Public Input No. 234-NFPA 13-2022 [Global Input]

NFPA® 13

Standard for the Installation of Automatic Sprinkler Systems

2022 Edition

Figure 19.2.3.1.1 Density/Area Curves for the Evaluation or Modification of Existing Systems.

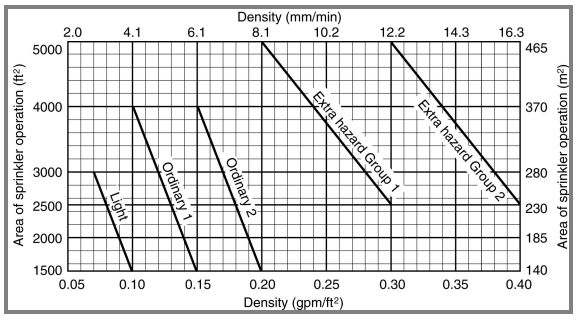
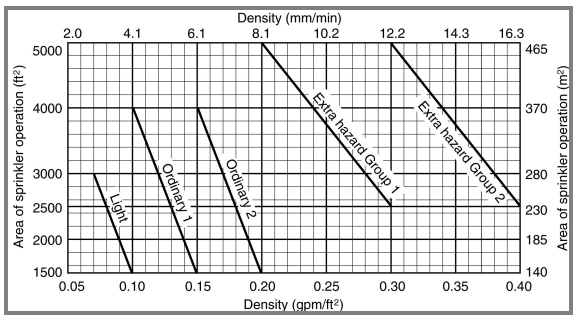
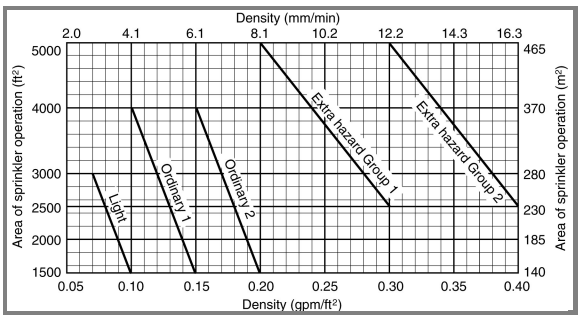
(2) For the evaluation or modification of existing systems, ~~the density/area curves of Figure 19.2.3.1.1 in accordance with the density/area method of 19.2.3.2~~ refer to Chapter 30.

(2) ~~For the evaluation or modification of existing systems, the density/area curves of Figure 19.2.3.1.1 in accordance with the density/area method of 19.2.3.2~~

The requirements in Section 19.2.3.1.1(2) are specific to existing systems and are being deleted due to a proposal to relocate these requirements into Chapter 30. See the proposal for relocating this language along with Figure 19.2.3.1.1 to Section 30.4.3.2. With the removal of references to existing systems in this section, the term “new” relative to systems can be removed from 19.2.3.1.1(1).

~~**Figure 21.2.2.3.2 For the Evaluation or Modification of Existing Systems, Sprinkler System Design Curves for 20 ft (6.1 m) High Storage — High Temperature–Rated Sprinklers.**~~

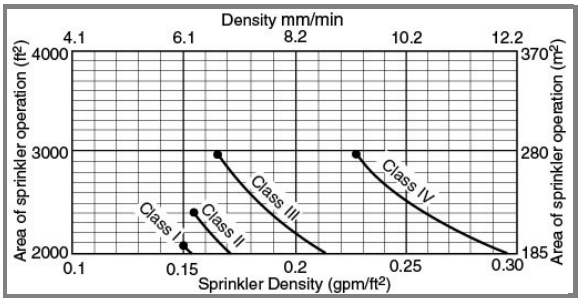
~~For the evaluation or modification of existing systems, where using high temperature–rated sprinklers, a single point shall be selected from the appropriate commodity curve on Figure 21.2.2.3.2 .~~

Statement: The existing system information is being removed from the standard. In Chapter 30 there will be a reference that states that you can reference legacy editions that were designed using the density/area curves.

~~Figure 21.4.1.7.1 Evaluation or Modification of Existing System's Ceiling Sprinkler Density vs. Storage Height.~~

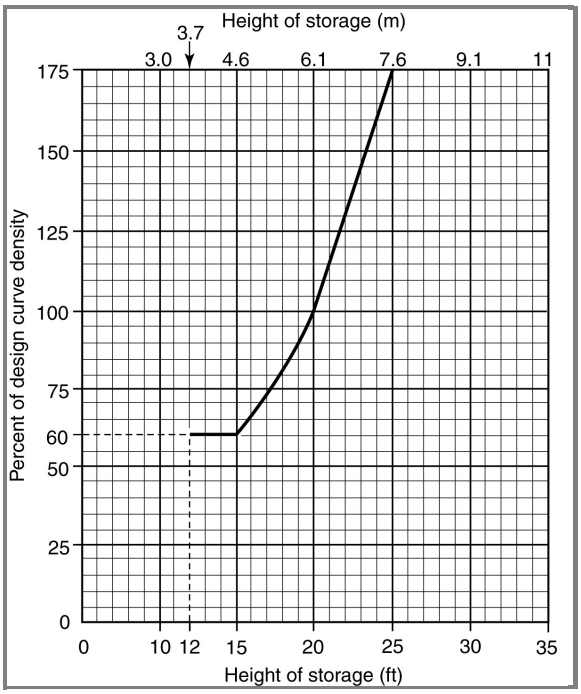
~~For the evaluation or modification of an existing system with storage height over 12 ft (3.7 m) up to and including 25 ft (7.6 m) protected with ceiling sprinklers only, densities obtained from design curves shall be adjusted in accordance with Figure 21.4.1.7.1 .~~

Statement: The existing system information is being removed from the standard. In Chapter 30 a reference has been added that states that you can reference legacy editions that were used to design the system, using the density/area curves.

Figure 25.3.1.3 CMDA Ceiling-Level Sprinkler Characteristics in Combination with In-Rack Sprinklers.

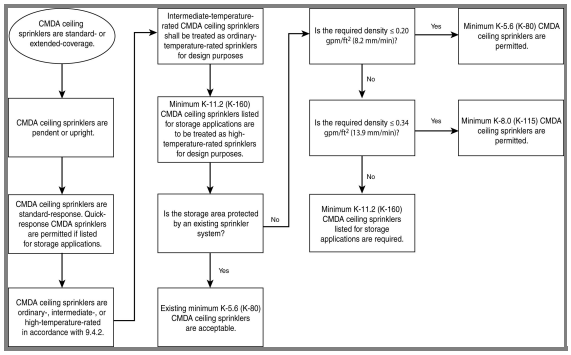
The new Figure 25.3.1.3 is within 25.3.1 (general to all IRAS with CMDA) and has a section stating any K-11.2 sprinklers listed for storage ‘are to be’ treated as high-temperature for design purposes. Believe the term her is ‘can be’ versus ‘are to be’.

Previous editions: The 2016 edition section 12.6.9 stated 'Ordinary- and intermediate-temperature sprinklers with K-factors of K-11.2 or larger, where listed for storage, shall be permitted to use densities for high temperature sprinklers’

Figure 25.6.2.3.1(b) In-Rack Sprinkler Arrangements for Class I through Class IV and Cartoned Group A Plastic Commodities, Maximum 30 ft (9.1 m) Vertical Increments.

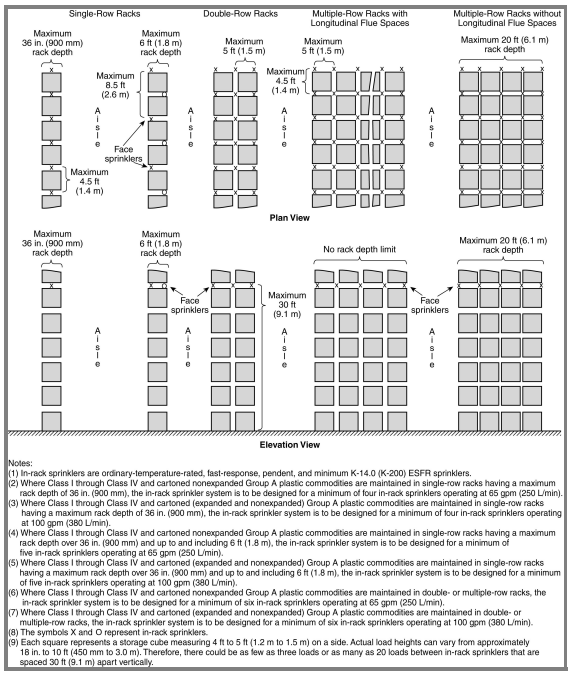
Revise Figure 25.6.2.3.1(b) so that it matches the in-rack sprinkler arrangements shown in former Figures 25.8.2.4(d) and 25.8.2.4(f) from the 2019 Edition of NFPA 13.

Figure 25.6.2.3.1(b) is the same drawing as Figure 25.6.2.3.1(c) and should have been a combination of Figures 25.8.2.4(d) and 25.8.2.4(f) from the 2019 Edition of NFPA 13.

Resolution: FR-1237-NFPA 13-2022
Statement: The in-rack sprinklers are indicated with both X and O and the note to the figure should indicate that. Figure 25.6.2.3.1(b) was revised to align with the 2016 edition figure.

Figure 25.6.2.3.1(e) In-Rack Sprinkler Arrangements for Class I through Class IV and Cartoned Group A Plastic Commodities, Maximum 30 ft (9.1 m) Vertical Increments.

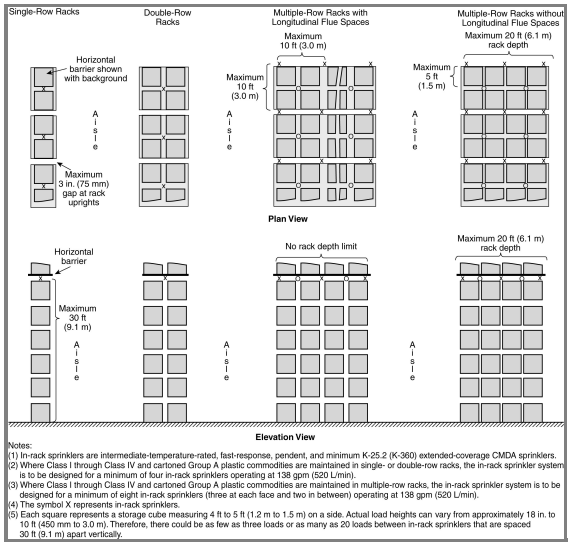
Add the wording "and O" to Figure 25.6.2.3.1(e) since the figure incorporate both "X" and "O" as in-rack sprinklers.

Resolution: FR-1237-NFPA 13-2022
Statement: The in-rack sprinklers are indicated with both X and O and the note to the figure should indicate that. Figure 25.6.2.3.1(b) was revised to align with the 2016 edition figure.

Figure 25.6.2.3.1(f) In-Rack Sprinkler Arrangements for Class I through Class IV and Group A Plastic Commodities, Maximum 20 ft (6.1 m) Vertical Increments.

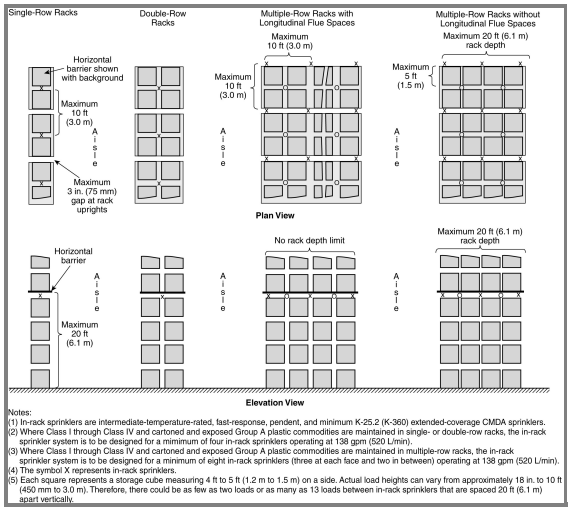
Add the wording "and O" to Figure 25.6.2.3.1(f) since the figure incorporate both "X" and "O" as in-rack sprinklers.

Resolution: FR-1237-NFPA 13-2022
Statement: The in-rack sprinklers are indicated with both X and O and the note to the figure should indicate that. Figure 25.6.2.3.1(b) was revised to align with the 2016 edition figure.
